MASTER DEVELOPMENT PLAN

MINOR AMENDMENT OF CARMONA HILLS M.D.P.# 049A-06

Re: Carmona Hills (Amended) **MDP # 049A-06**

The City Staff Development Review Committee has reviewed the Carmona Hills Master Development Plan **M.D.P. # 049A-06**. Please find enclosed a signed copy for your files. Your plan was approved for acceptance; however please note the following conditions:

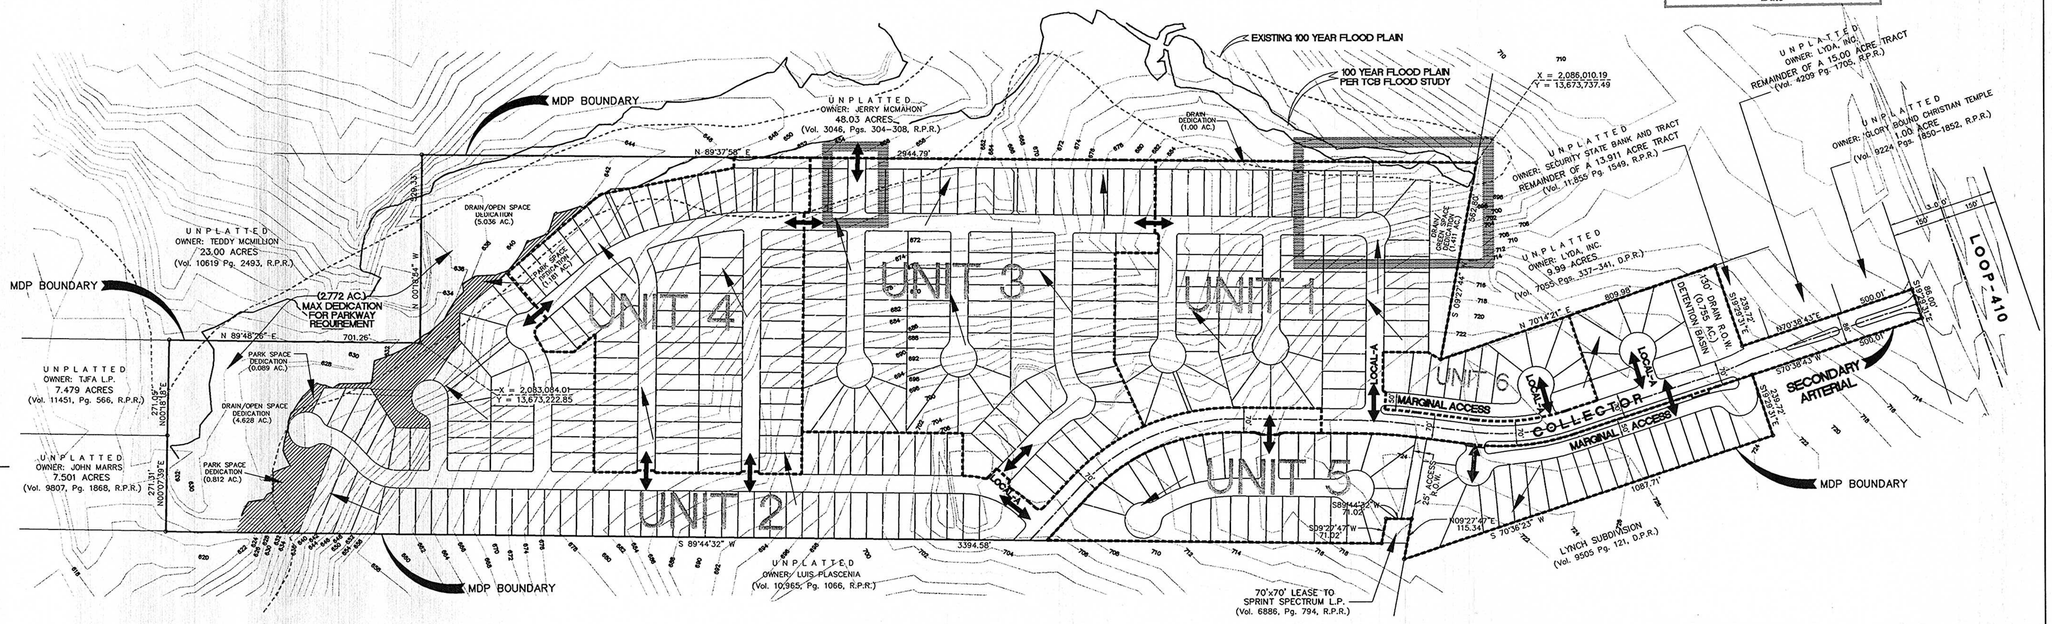
In consideration of public safety and convenience, excessive grades by reason of topography should be avoided in street layouts and arrangements. Any access and R.O.W. issues along state facilities will need to be resolved with the **Texas Department of Transportation (TXDOT)**. For information about these requirements you can contact TXDOT at 615-5814.

- All access driveways shall comply with UDC 35-506 (r).
- All roadways shall conform to Table 506-2 Functional Classification System Description for Traditional Design Classification.
- All sidewalks shall comply with UDC 35-506 (q).
- All access roadways shall provide clear sight distance on all existing and proposed roadways in order to provide adequate obstruction free viewing distances from approaching traffic. All signage, landscaping, and improvements shall be selected and located so as to not block these clear sight distances areas.
- A right turn deceleration will be required to be installed as per TxDot requirements.

- The parkland provided shall be shown as "Park" or "Open Space" on a plat; UDC section 35-503(e) *Designation of Parkland.*
- The parkland provided is dedicated to the Homeowners Association.
- The instruments creating the Homeowners Association are provided by the second application for plat approval; UDC section 35-503(e) *Designation of Parkland.*
- Parkland dedication shall be platted by the second phase of residential development; UDC section 35-503 (f) *Development Phasing.*
- All amenities provided shall comply with standards and specifications found in UDC section 35-503(h) *Credit Park Facilities* and Table 503-4 if any credit is to be awarded.

- 2003 Tree Preservation ordinance standards per UDC Section 35-523 – a Master Tree Permit (AP 1301746) has been issued for this project using the Tree Canopy Method – no removal permitted in flood plain and plan indicates 45% preservation on site. A $75 fee will be charged at platting for follow-up inspections.
- Streetscape standards per UDC Section 35-512 – The Secondary Arterial and Collector streets to be constructed require streetscape trees. Estimates of planting costs and plan and profiles for streetscape will be required at platting stage.
